UNITED STATES PATENT AND TRADEMARK OFFICE

APPLICATION NO.	FILING DATE	FIRST NAMED INVENTOR	ATTORNEY DOCKET NO.	CONFIRMATION NO.
10/773,631	02/06/2004	Alexander Star	612407-23	8346
23879	7590	04/04/2006	EXAMINER	
BRIAN M BERLINER, ESQ O'MELVENY & MYERS, LLP 400 SOUTH HOPE STREET LOS ANGELES, CA 90071-2899			SINES, BRIAN J	
			ART UNIT	PAPER NUMBER
			1743

Office Action Summary

DETAILED ACTION

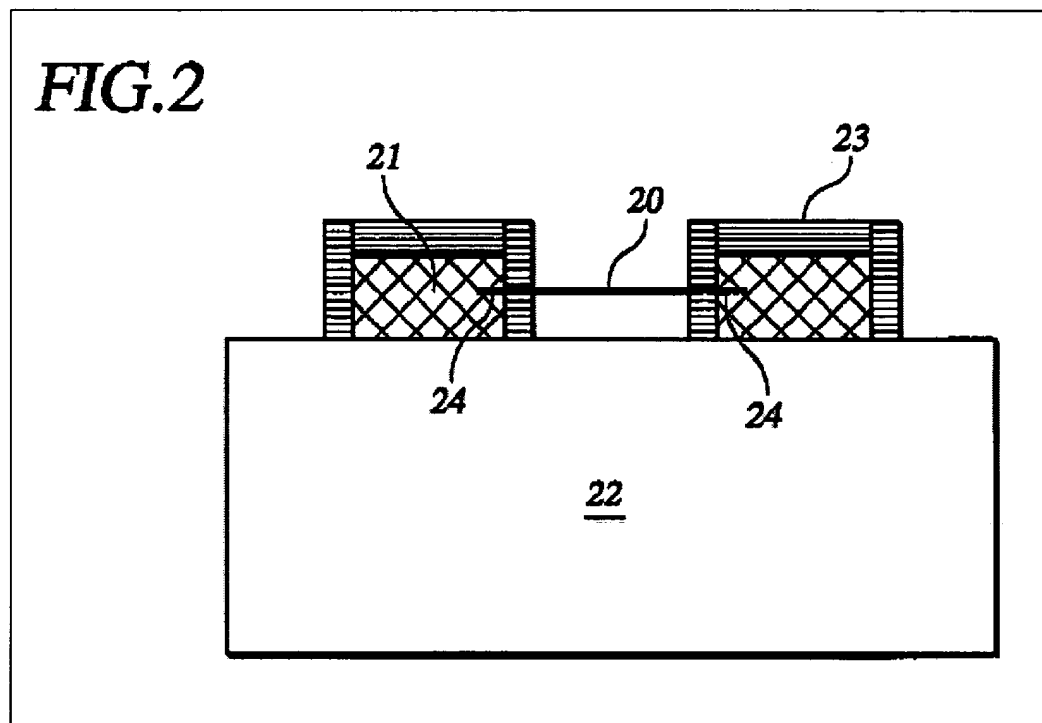
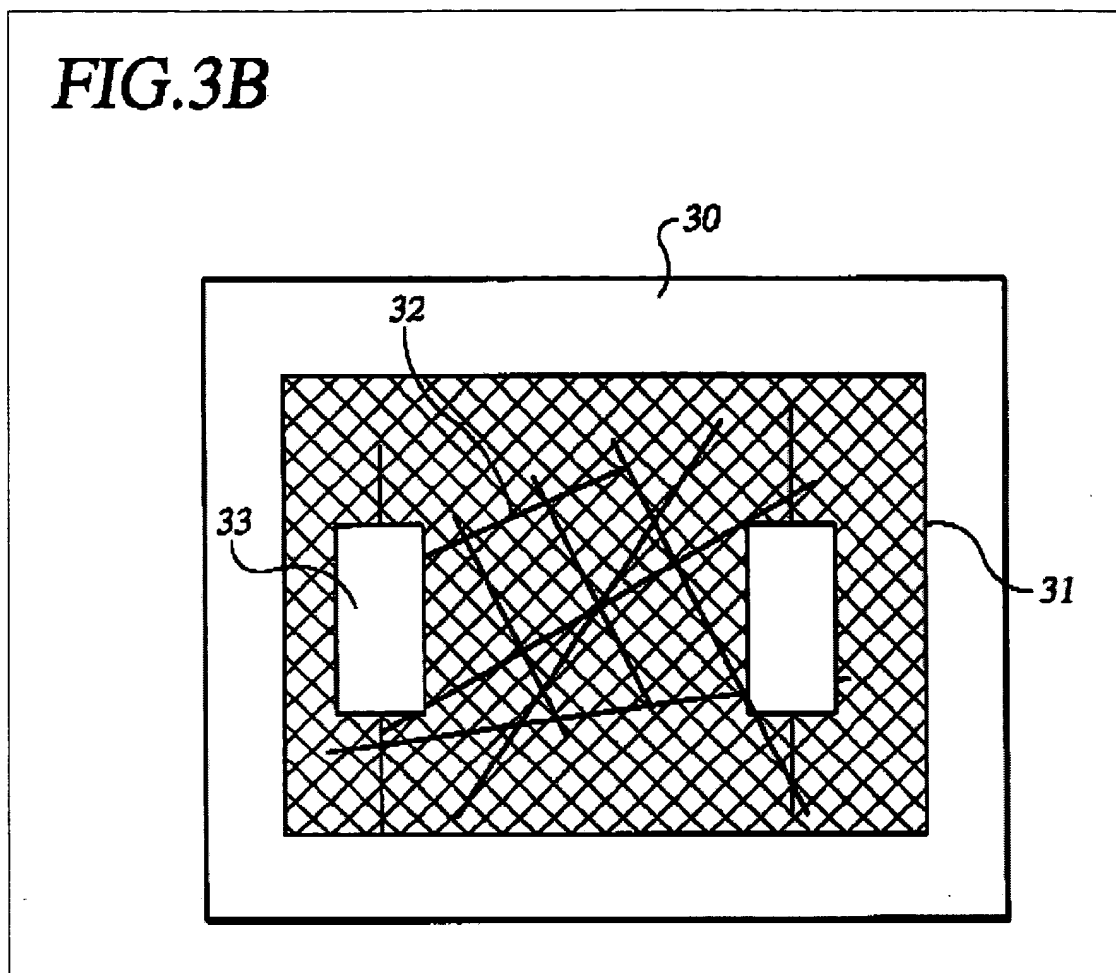
Regarding claims 1 and 2, Dai teaches an apparatus comprising: a substrate 22, 30; at least one nanotube 20, 32 disposed on the substrate; at least one electrical contact 23, 33, wherein the contact is in electrical communication with the at least one nanotube (see figures 2 and 3B; col. 4, lines 23 – 65).

Regarding claim 3, as shown in figures 2 and 3B, the nanotube 20, 32 spans the distance between two electrical contacts 23, 33.
